South Texas Project Electric Generating Station 4000 Avenue F – Suite A Bay City, Texas 77414

February 10, 2010
U7-C-STP-NRC-100036

South Texas Project
Units 3 and 4
Docket Nos. 52-012 and 52-013
Response to Request for Additional Information

Attached are the responses to the NRC staff questions included in Request for Additional Information (RAI) letter numbers 299 and 302 related to Combined License Application (COLA) Part 2, Tier 2, Sections 3.7.1, 3.7.2 and 3.8.4.

Figure 3H.6-15a: SSI Model (structure only)

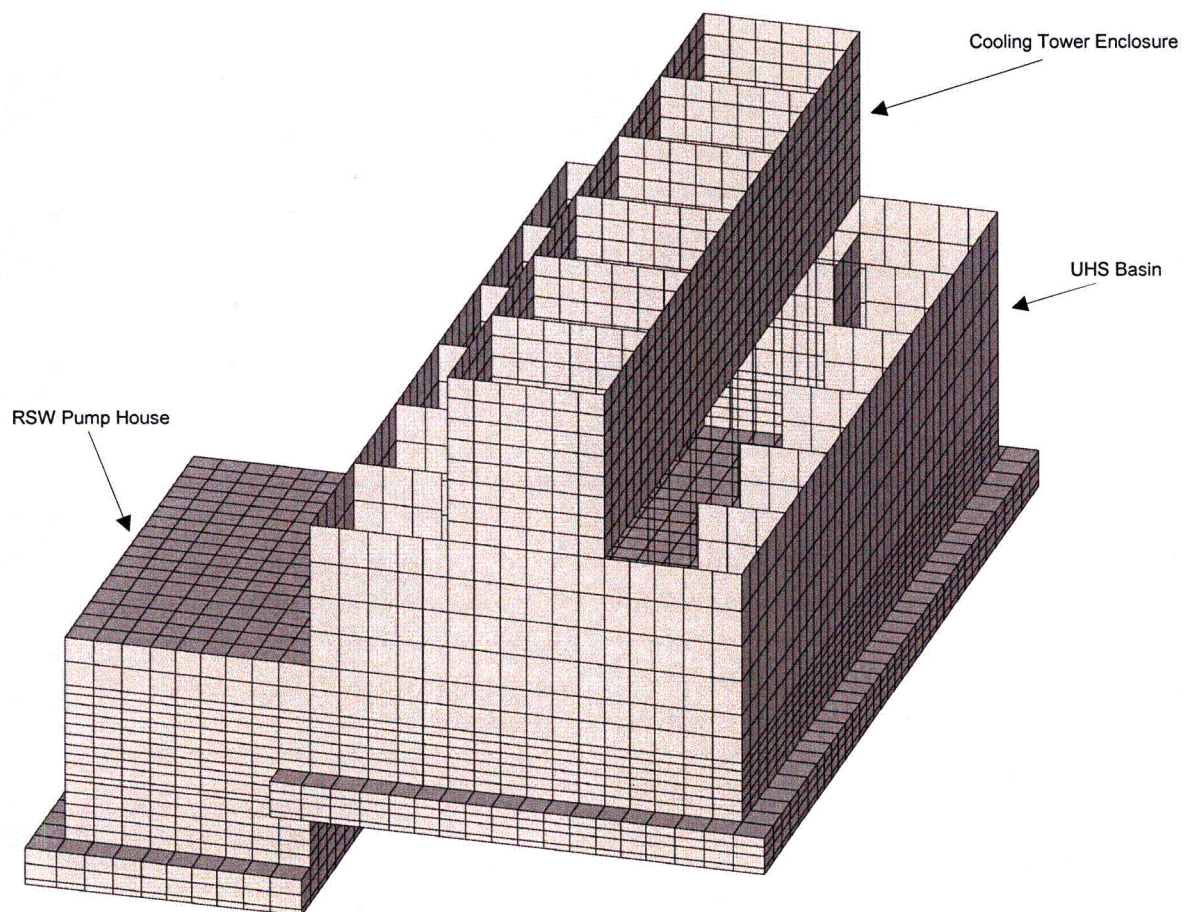
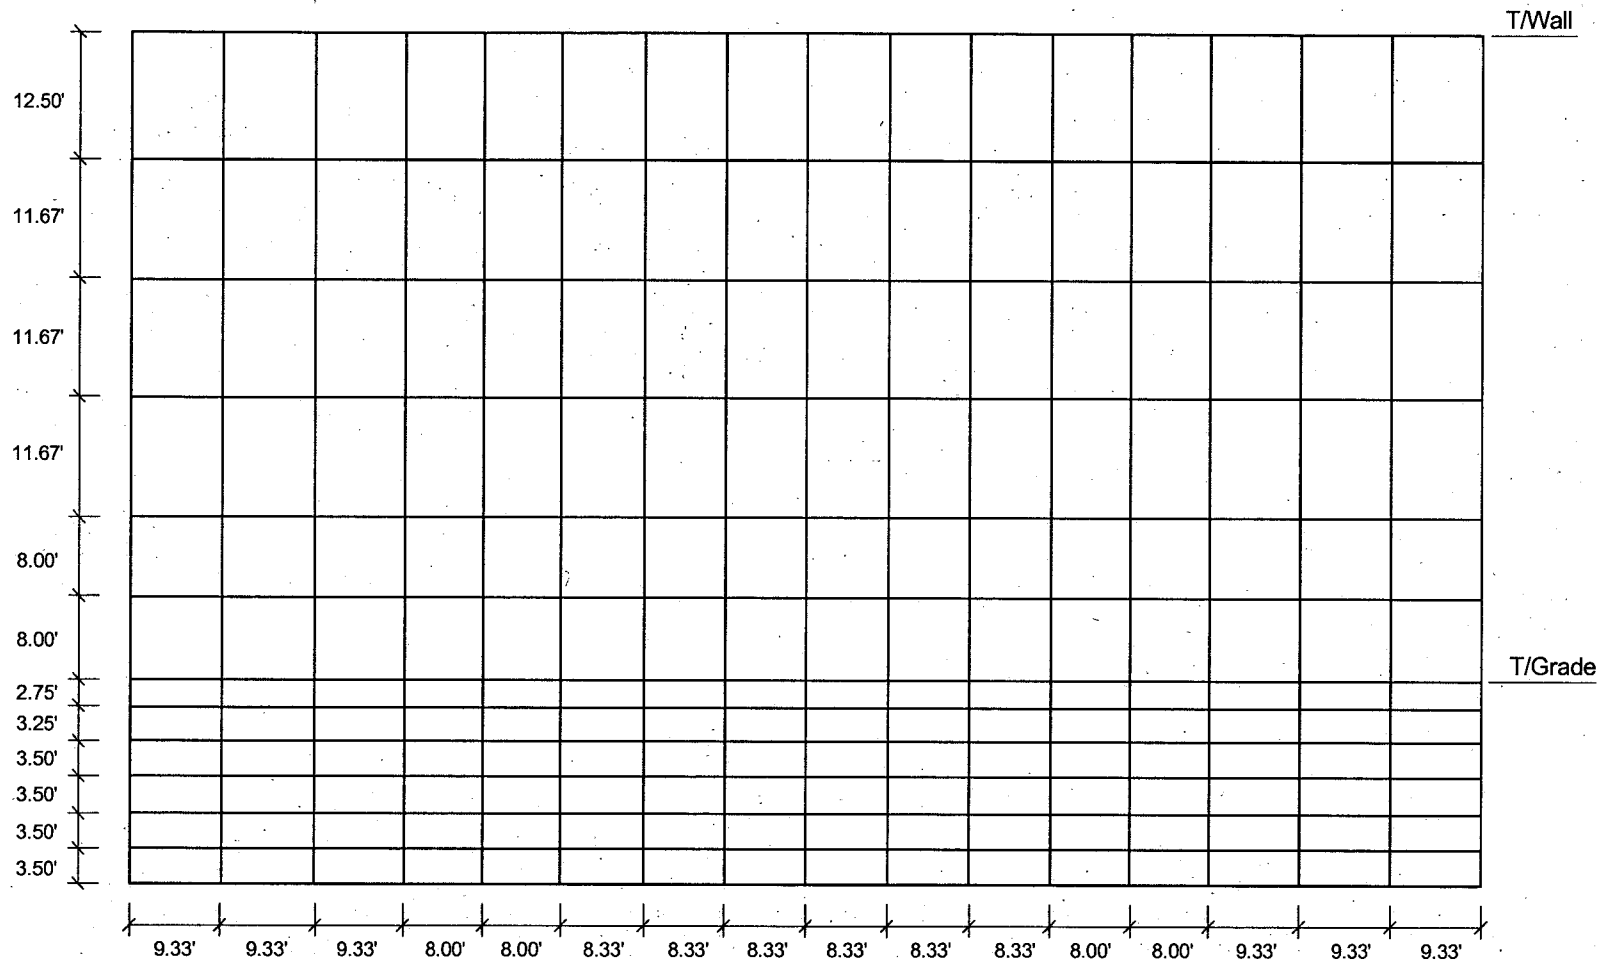
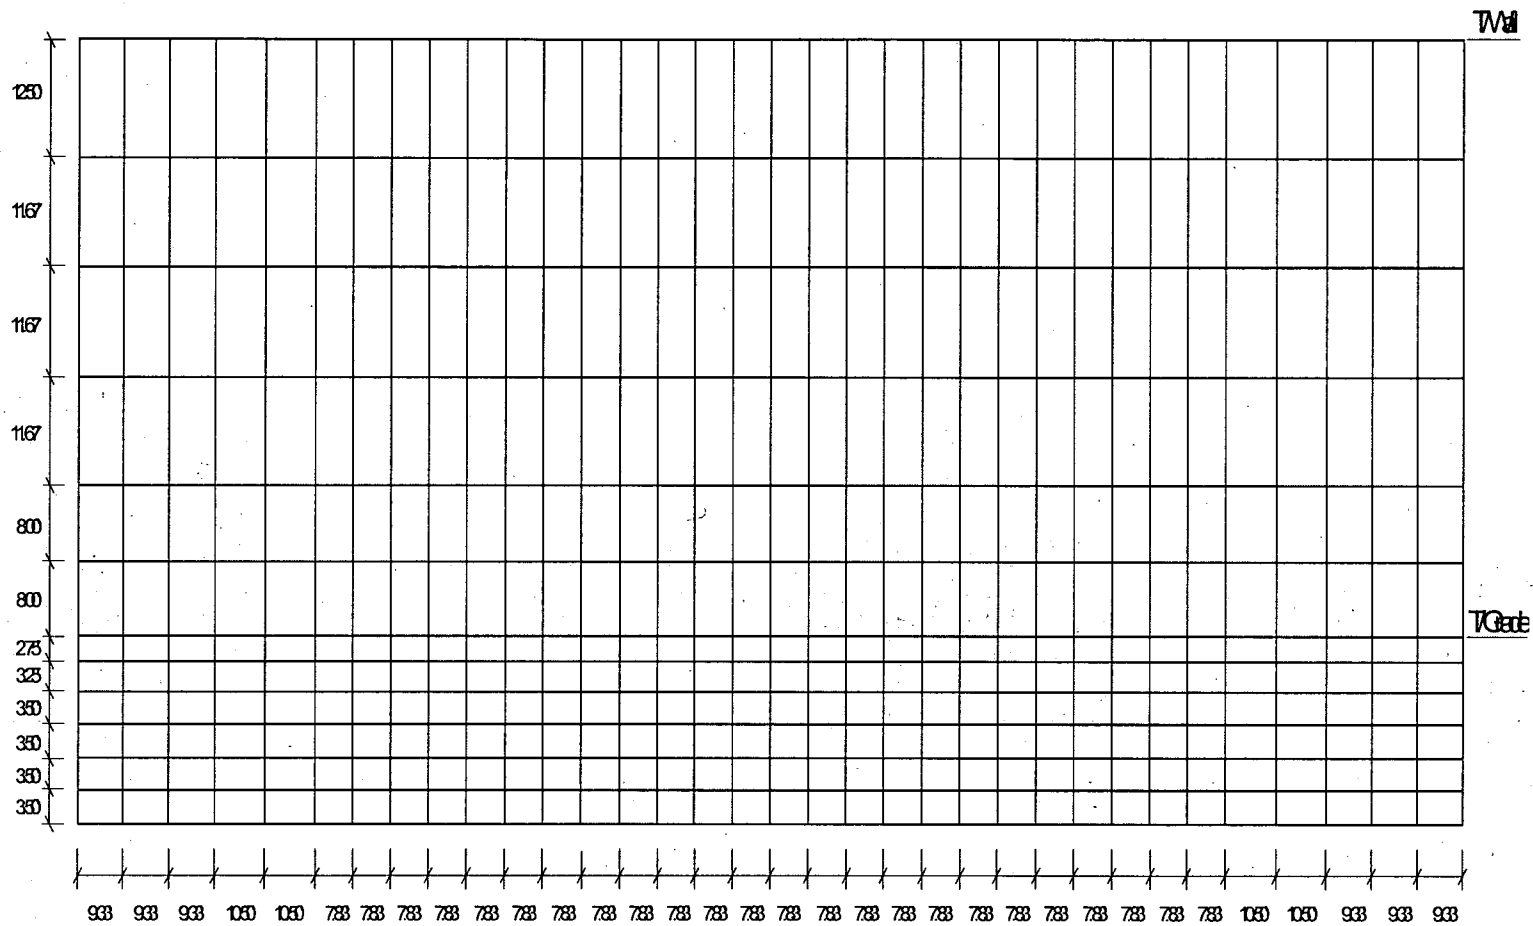
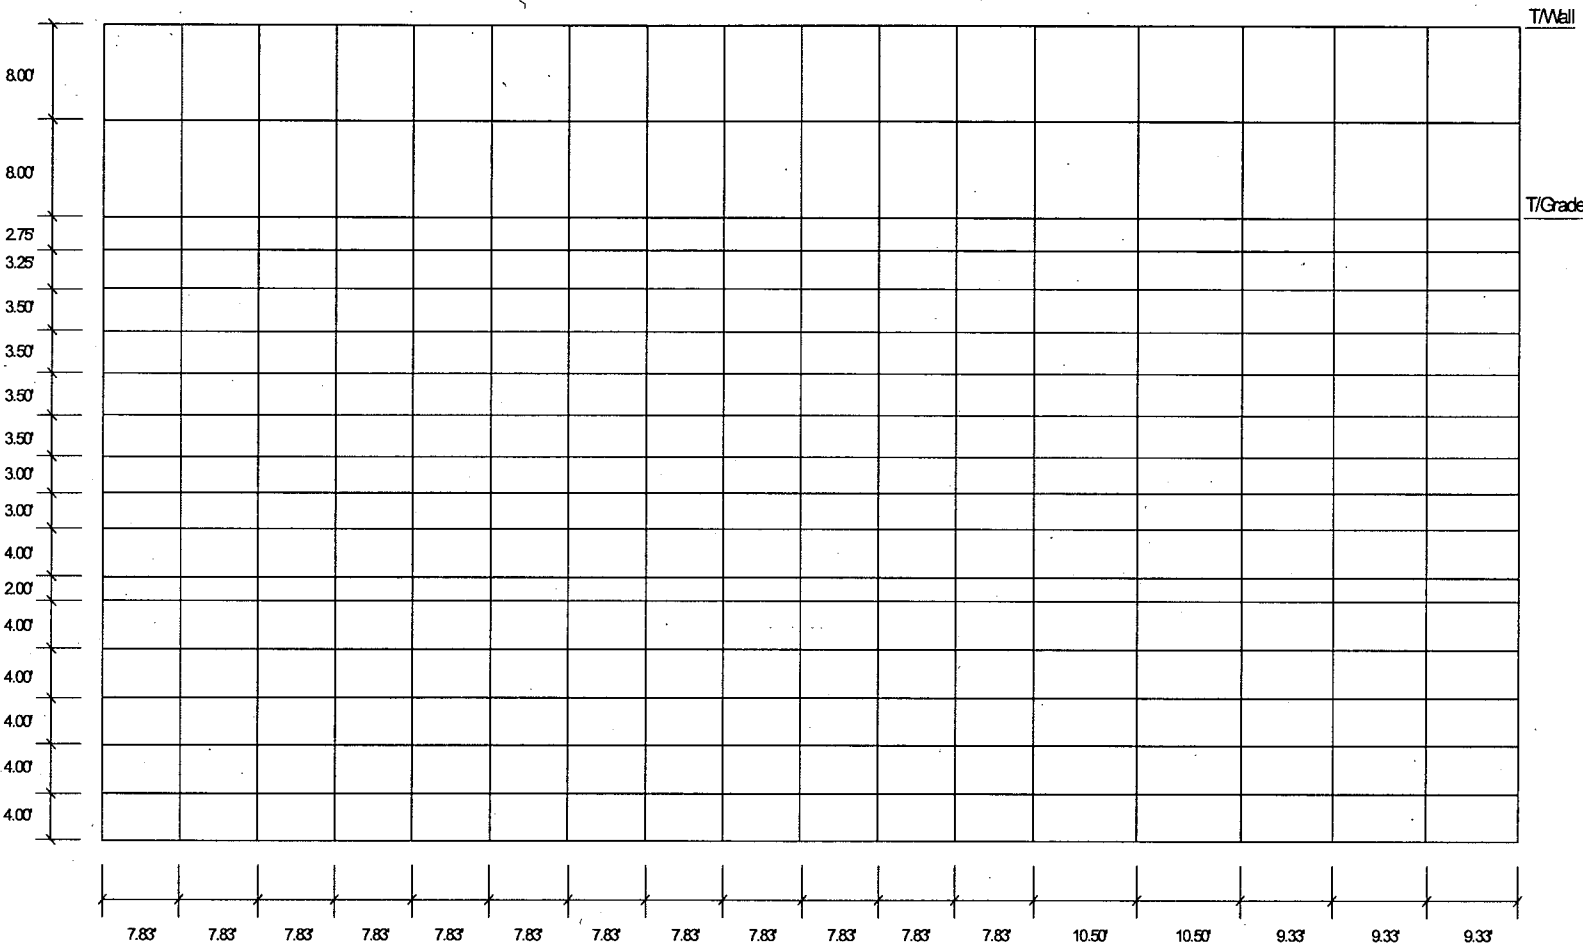
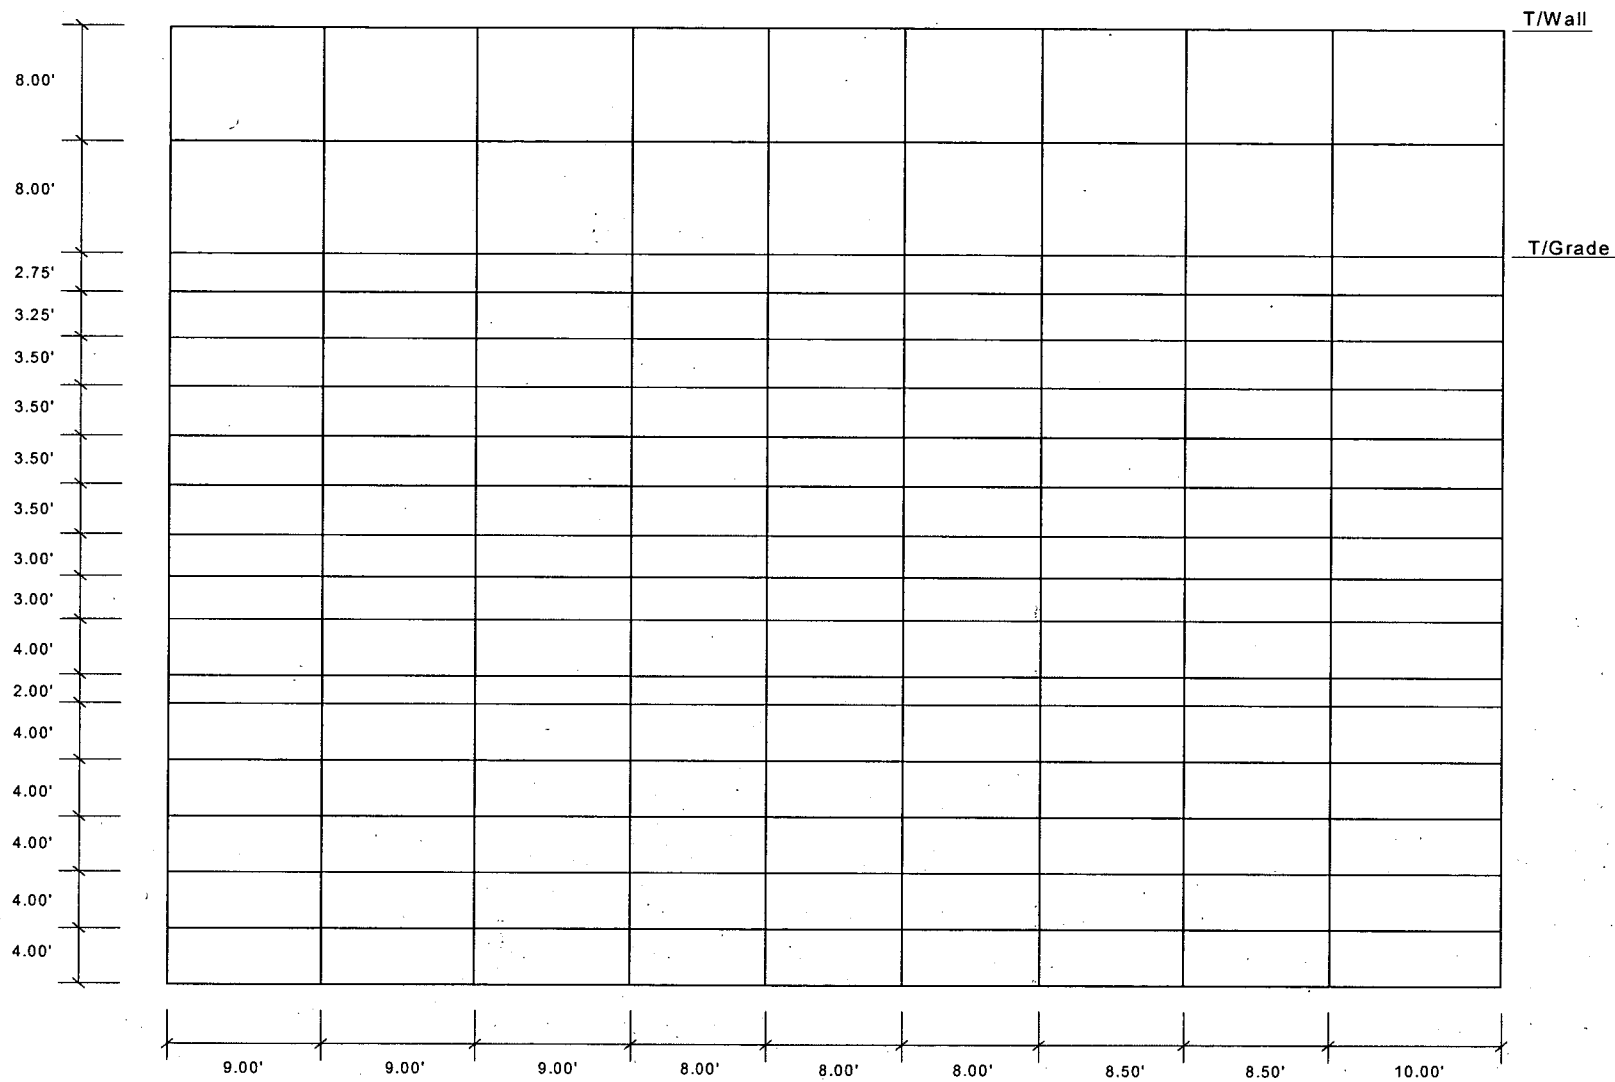
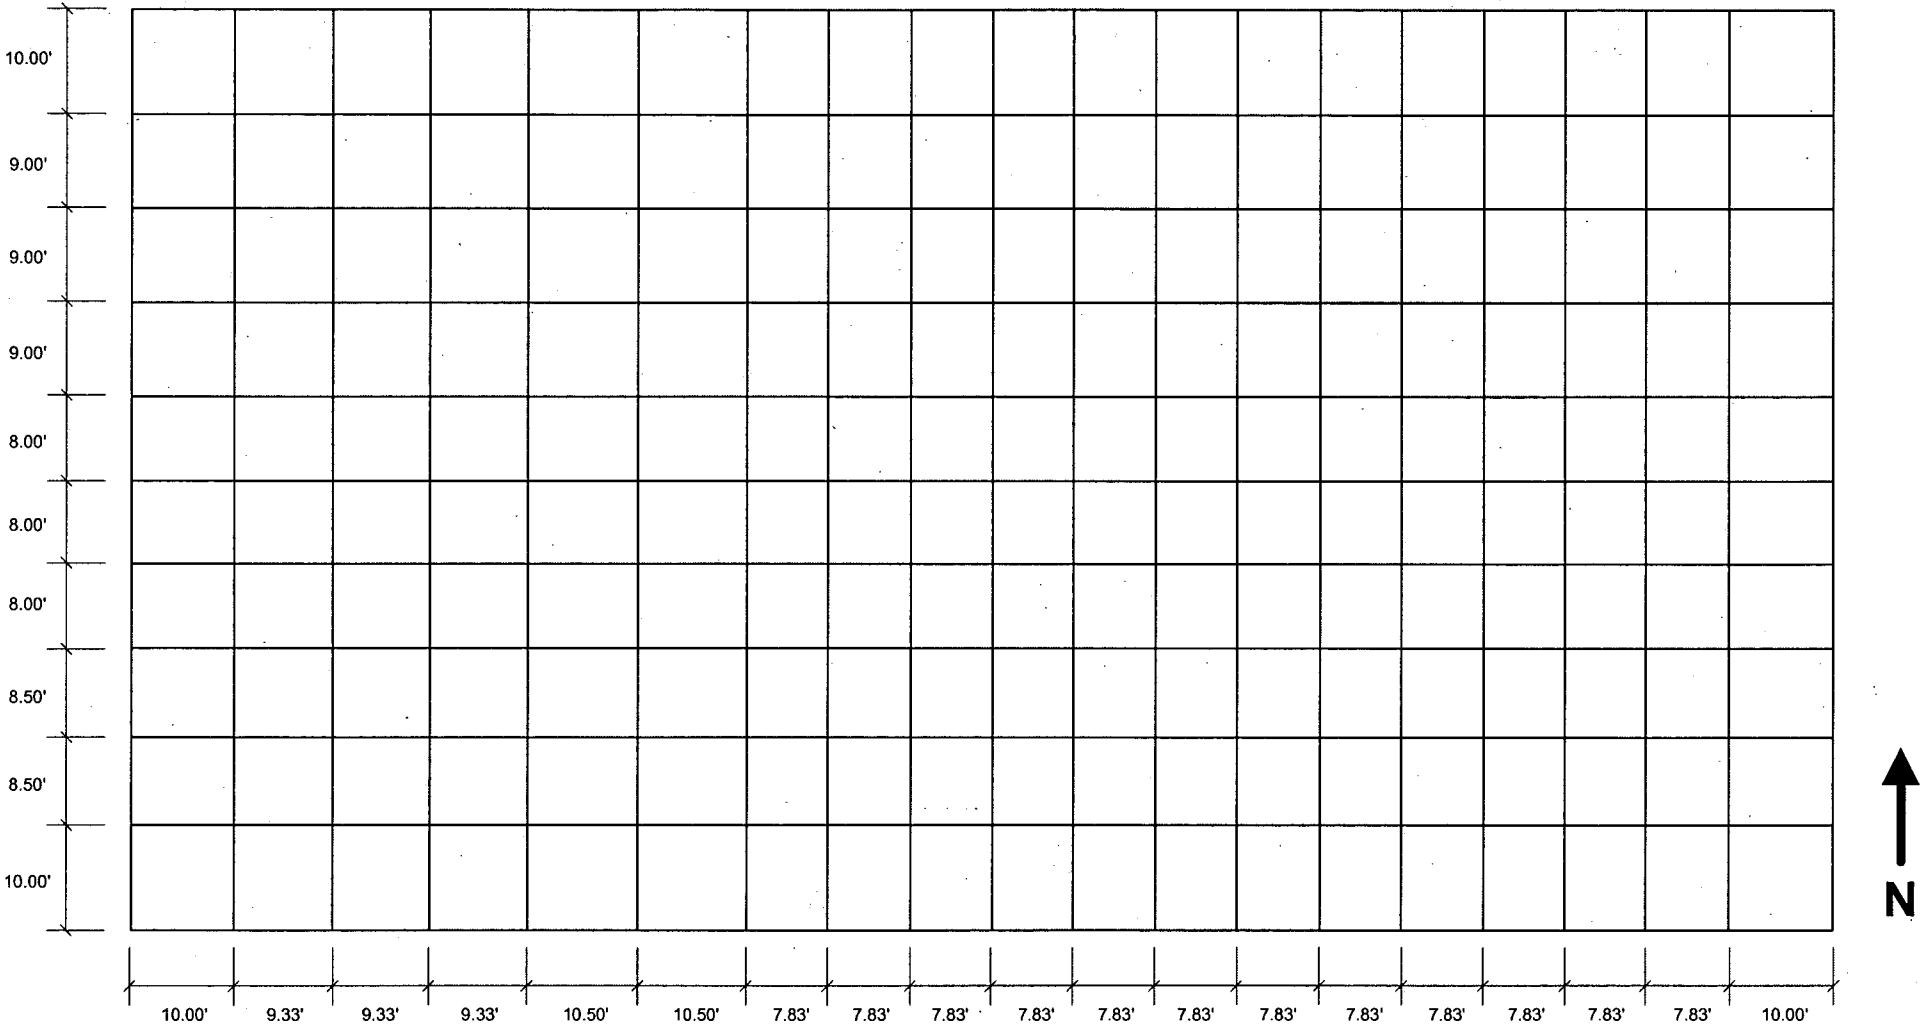
1. In the response to Item 2 of RAI 03.07.01-4, the finite element model of the UHS basin and RSW Pump House was not provided in Figure 3H.6-40 (this figure was supposed to be part of the response to RAI 03.07.01-13). The applicant is requested to ensure this information be part of Figure 3H.6-40, including a plot showing the basement slab and soil-retaining wall mesh configuration and grid sizes. The response to Item 2 of RAI 03.07.01-4 also states that, ***"The model mesh size is detailed enough to model the principal features of the structure and transmit a frequency of at least 33 Hz."*** The applicant is requested to a) provide the criteria and quantitative basis to show that the element sizes are sufficiently small to transmit frequencies of up to 33 Hz for the three soil cases; and b) provide a justification that the aspect ratio of the elements is sufficiently small as not to affect the solution accuracy.

Figures 3H.6-15a through 3H.6-15g on the following pages provide the structure model used in the SSI analysis along with the additional requested information regarding mesh configuration and grid size of the basemat and the exterior walls.

Figure 3H.6-137: Formulations Used for Calculation of Factors of Safety Against Sliding and Overturning

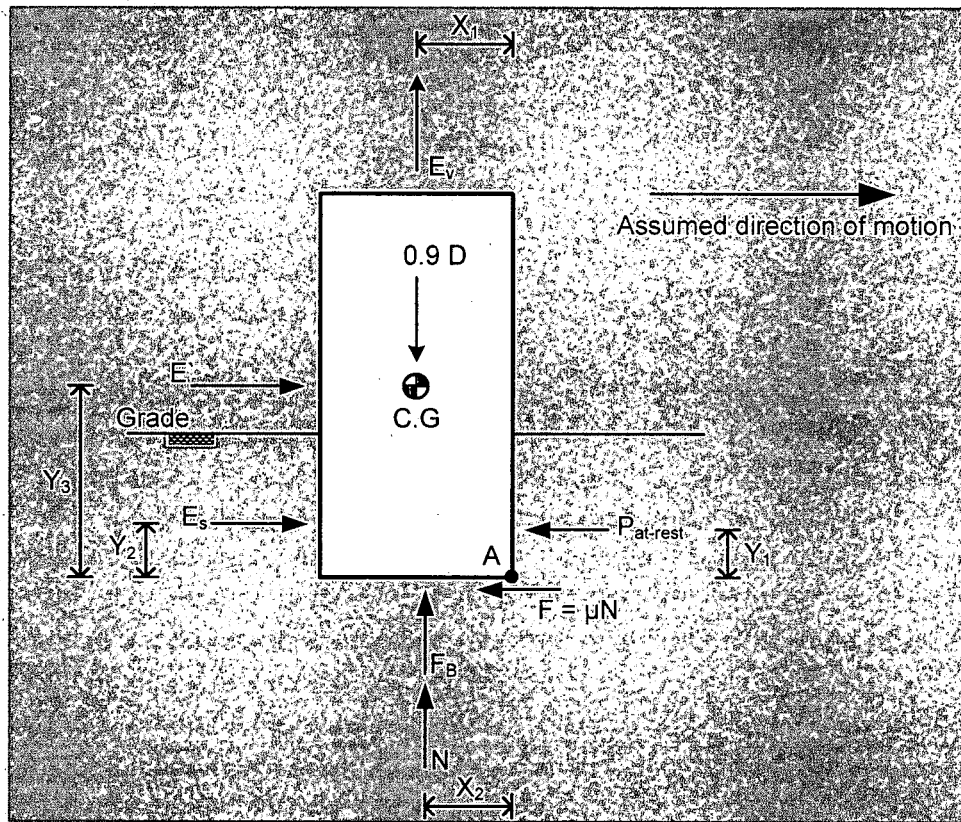
4. In the seventh and last bullet of the response to RAI 03.07.02-10, Figure 1 attached to this response shows the driving force "Es" as static and dynamic soil pressure but does not clarify the nature of the static soil pressure. The applicant is requested to clarify the nature of the driving static soil pressure in Figure 1. Also, please clarify how total at-rest soil pressure is calculated including algebraic expression. This figure with the above clarification should be included in the FSAR.

As requested, Figure 1 of the response to RAI 03.07.02-10 will be included in COLA Part 2, Tier 2 as new Figure 3H.6-137; see attached COLA mark-up.
